**RE: License No. 37-07653-02
Docket No. 030-06172**

Alcoa Research Laboratory

Addendum to Final Status Survey Plan and Report

Response to NRC Questions

ALCOA Research
Laboratory
Building 29 Pressroom/Toolroom

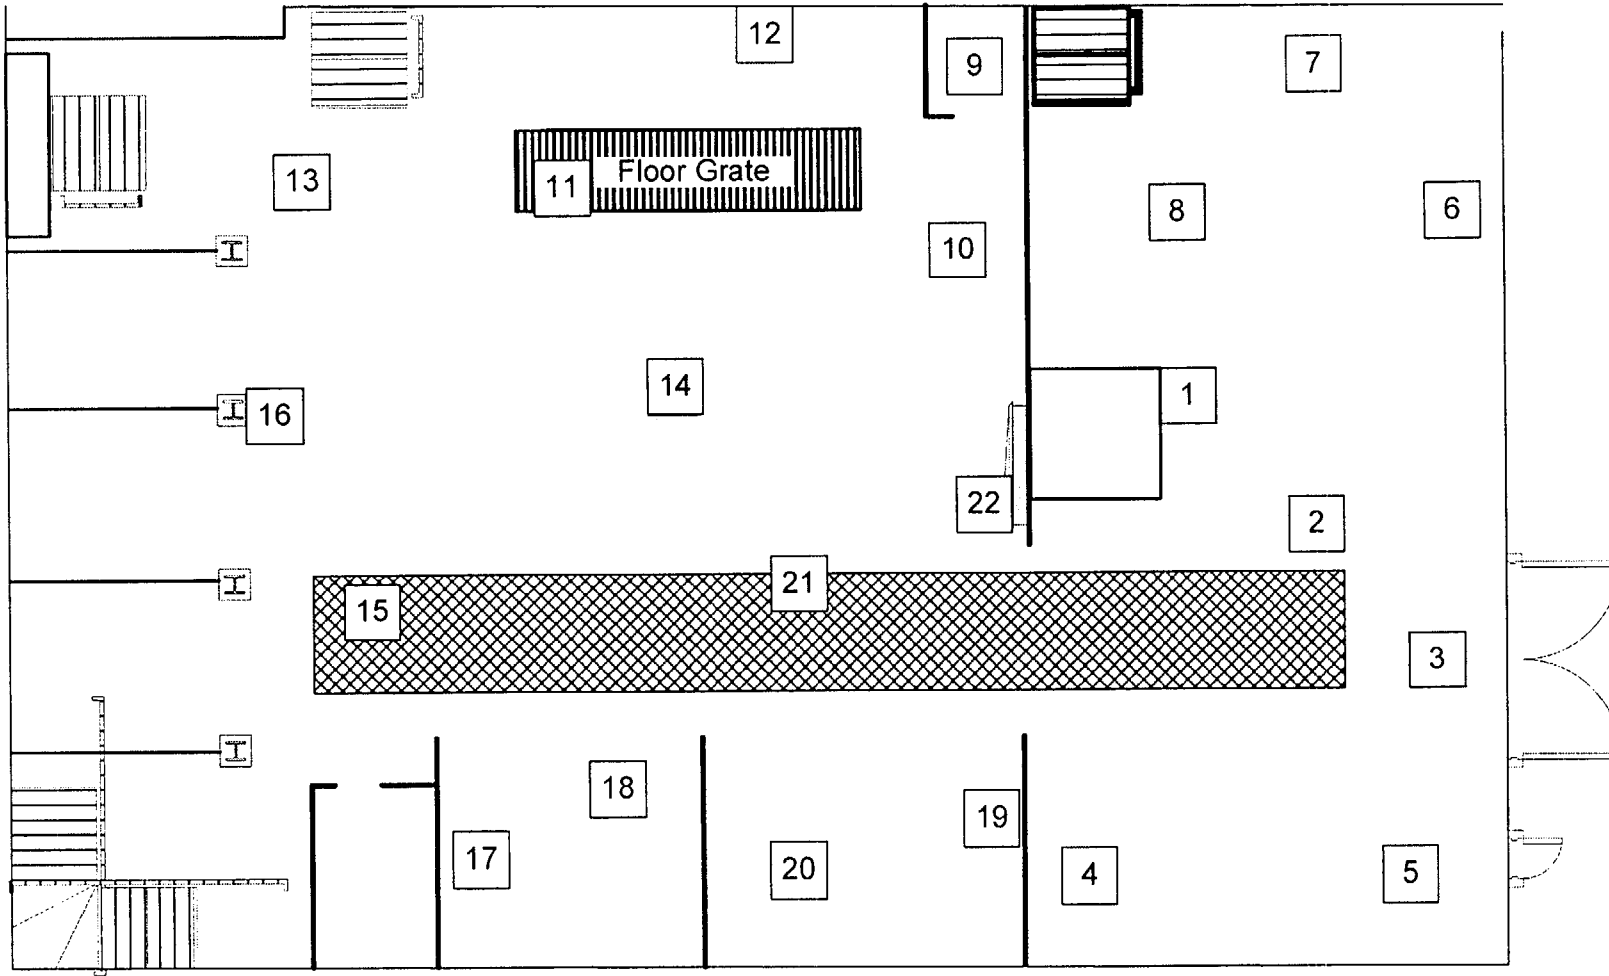
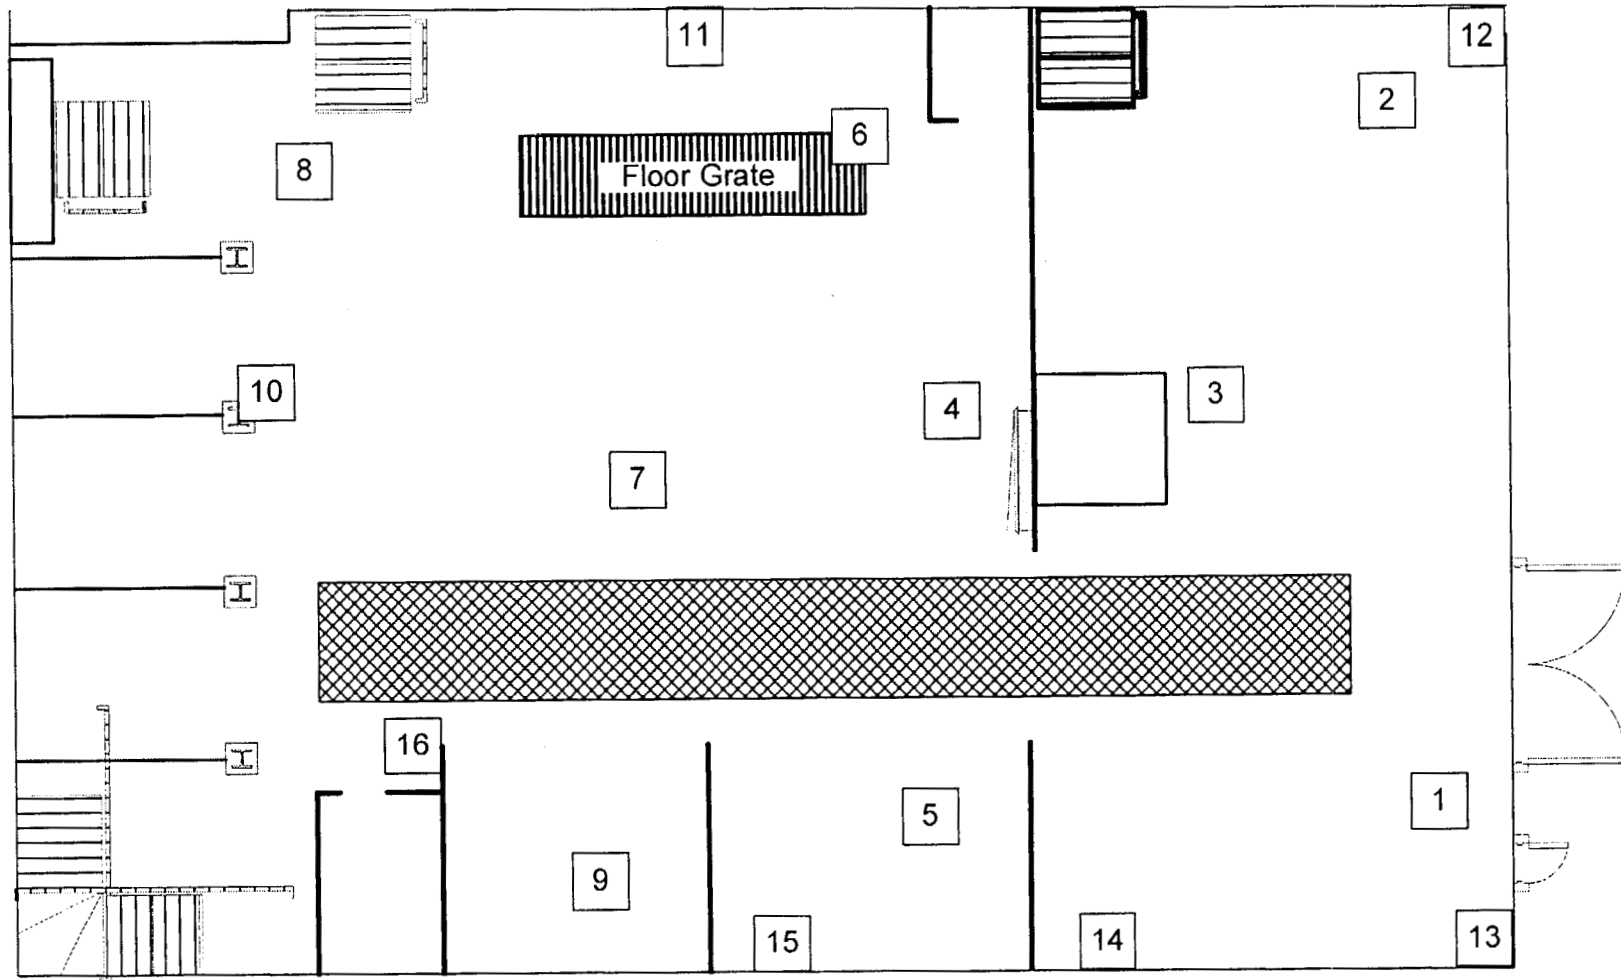
- b. A 20' x 25' laboratory in Building 29 had a gas handling system for tritium experiments.
 - c. A lathe in the press room in Building 29 was set aside for tool wear studies using radioactive materials (possibly cobalt-60).

No one who was contacted had any recollection of tool wear studies being performed in Building 29. The 1958 inspection report clearly indicates Co-60 was used, and that is consistent with what would be expected. The Press Room is a 65' x 26' room on the east side of Building 29. It is adjoined by the former machine shop, a 65' x 52' room. The inspection report indicated the tool wear studies were conducted in a containment area. Nearly eight half-lives have lapsed since this activity was conducted. In light of these facts, and to ensure nothing was missed, both rooms were surveyed as Class 3 areas. No areas of elevated activity were found during either the characterization survey or the final status survey. Because results of static counts were all less than 0.1 times the default screening value, and most were less than MDA, surveys for removable contamination were not required. A copy of the survey is attached.

ALCOA - Building 29 Basement (U238 Processing Area)

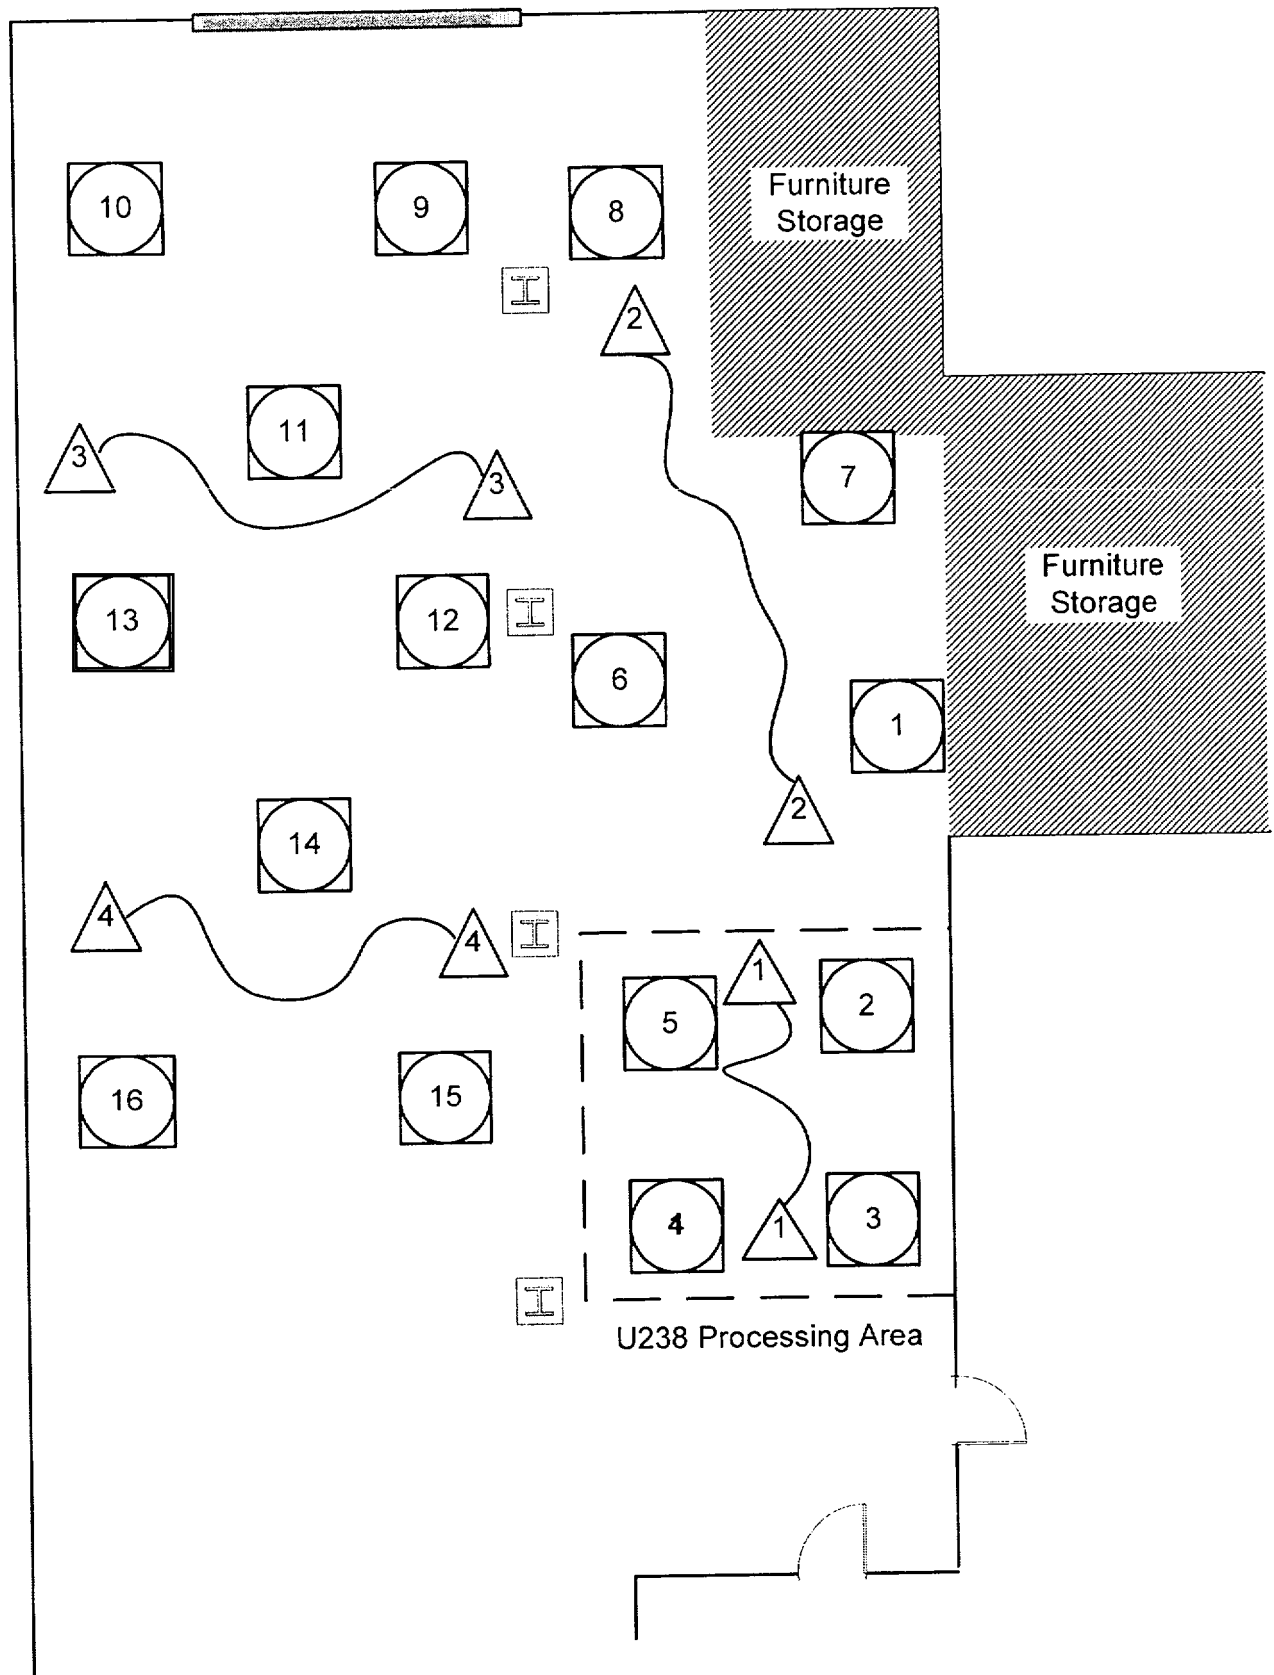
6. In your letter dated October 16, 2003, you requested to release the ARL for unrestricted use based on a radiological survey report dated October 1992. In this report, it was noted that uranium-238 was used in the basement of Building 29. In our response dated December 11, 2003, we explained that additional site specific information was needed that you should follow the guidance in NUREG 1757, Volume 1. In your latest letter dated June 21, 2005, there is no mention of the uranium-238 usage. According to a review of the license amendments, License No. 37-07653-02 did not authorize the use of

uranium-238. Please provide an explanation as to the residual contamination remaining at the site and the potential for U-238 contamination.

Use of uranium-238 occurred during the Manhattan Project and appears to have been completed before licenses were issued by the Atomic Energy Commission. The portion of the Building 29 basement where U-238 work was performed was surveyed on July 11, 2006. Surveys consisted of surface scans for gross alpha and gross beta, static measurements for gross alpha and gross beta, large area wipes, and smears which were counted for gross alpha and gross beta. No areas of elevated radioactivity were noted. All survey results were below the default levels contained in NUREG 1757, Volume 1. A copy of the survey is attached for review.
